Access Compliance Report

Public Rights-of-Way

Intersection ID: 47907	Main Street: E_MALLARD_CREEK_CHURCH_RD	Cross Street: JOHN_KIRK_DR	Location: S
ADA ID: 6CB606D1D7BD	Ramp Type: Perp	Initial Pass/Fail: Fail	Overall Compliance: No
Severity Score: 10			
Codes/Mitigation Info/Possible Solution		Field Measurements/Component Compliance

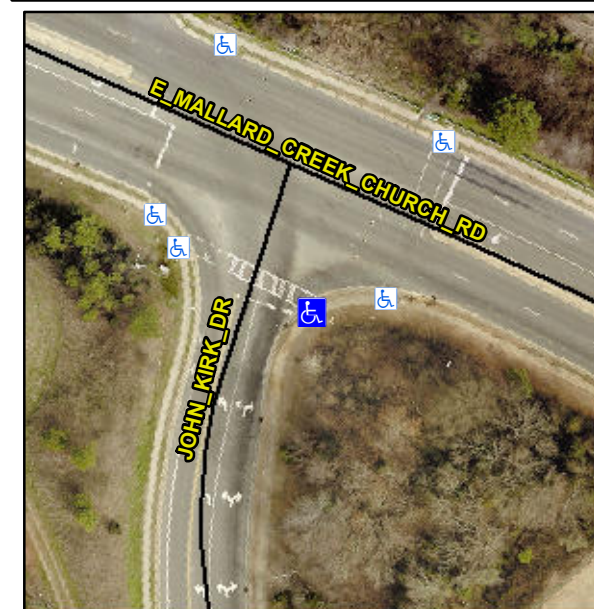
R304.5.1, R304.5.3

Compliance	Description	Data	Compliance	Description	Data
N/A	Ramp Length (in)	72.5	Yes	Ramp Slope (%)	7.5
No	Ramp Width (in)	43.0	No	Ramp XSlope (%)	2.6
N/A	Flare Type LT	N/A	N/A	Flare Type RT	N/A
N/A	Flare Slope LT (%)	N/A	N/A	Flare Slope RT (%)	N/A
N/A	Flare Traversable LT?	N/A	N/A	Flare Traversable RT?	N/A
N/A	Landing Length (in)	N/A	N/A	DWS Provided?	N/A
N/A	Landing Width (in)	N/A	N/A	DWS Contrast?	N/A
N/A	Landing Slope (%)	N/A	N/A	DWS Length (in)	N/A
N/A	Landing X Slope (%)	N/A	N/A	DWS Full Width?	N/A
N/A	Landing Curb? (Y/N)	N/A	N/A	DWS Offset (in)	N/A
N/A	Shared Landing?	N/A			
N/A	Gutter Ponding?	N/A	N/A	Gutter Slope (%)	N/A
N/A	Gutter Lip Ht (in)	N/A	N/A	Gutter X Slope (%)	N/A
N/A	Painted X Walk1?	Yes	N/A	Painted X Walk2?	N/A
	X Walk 1 Direction	To NW		X Walk 2 Direction	N/A
N/A	X Walk 1 Width (in)	101.0	N/A	X Walk 2 Width (in)	N/A
	X Walk 1 Slope (%)	1.9		X Walk 2 Slope (%)	N/A
	X Walk 1 X Slope (%)	1.4		X Walk 2 X Slope (%)	N/A

Remove & Replace Entire Ramp.
